Subject: [EXTERNAL] King's Bay Entrance and Inner Channel SAP/QAPP

Gary and I have completed our review of the King's Bay SAP/QAPP, and we do have some comments that should be addressed before sampling occurs in January. Our main concerns are summarized below:

U.S. ARMY CORPS OF ENGINEERS SAJ-1992-01854(SP-BAL) DATE: 22 OCTOBER 2012 DRAWING PAGE: 3 OF 5

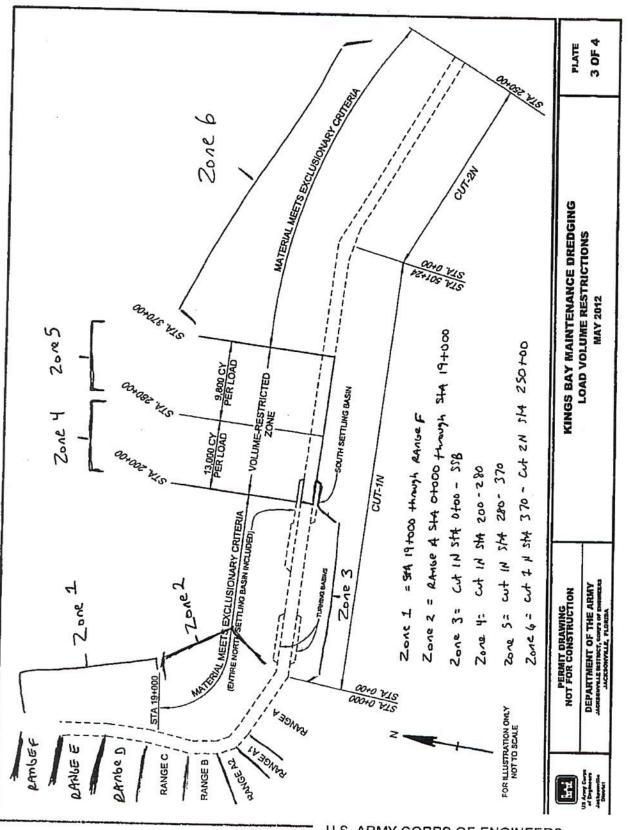
For 'Notes item 4' on the Kings Bay SAP Reviewer Checklist provided, you mention a map (attached). This did not come through on the email. Can you please resend. I wanted to see what or where you guys proposed the split to Zone 2.

Sorry about that. Please find the map attached.
